**DA2025/0077**

**DA SUBMISSION – 10-28 LAWRENCE STREET, FRESHWATER**

### 3. Lack of sufficient retail parking

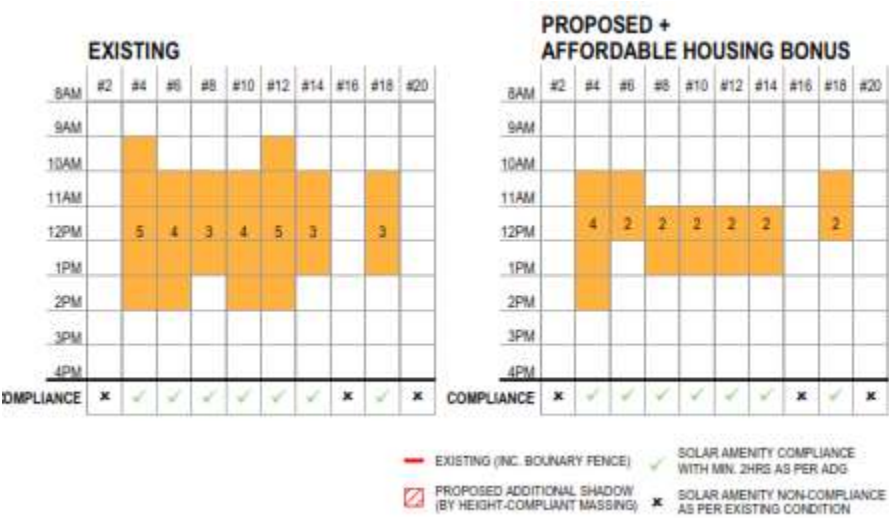
The Warringah DCP requires 72 retail parking spaces.

The development provides 62 spaces, 10 spaces short.

The submitted traffic report provides no reasonable argument for the shortfall in parking provided. Parking in Freshwater is very difficult, and the lack of sufficient parking will place further stress on the availability of street parking which will impact on parking for local residents. Providing additional retail GFA without sufficient parking is contrary to the provisions of the DCP and will impact on public parking in the area.

- Reduction in building height to comply with the maximum height permitted
- Increase setbacks to the southern boundary to comply with ADG separation requirements
- Provide an additional 10 retail parking spaces
- Amend the building envelope to ensure all dwellings to the south retain a minimum of 3 hours solar access between 9am to 3pm as per Clause D6 of Warringah DCP
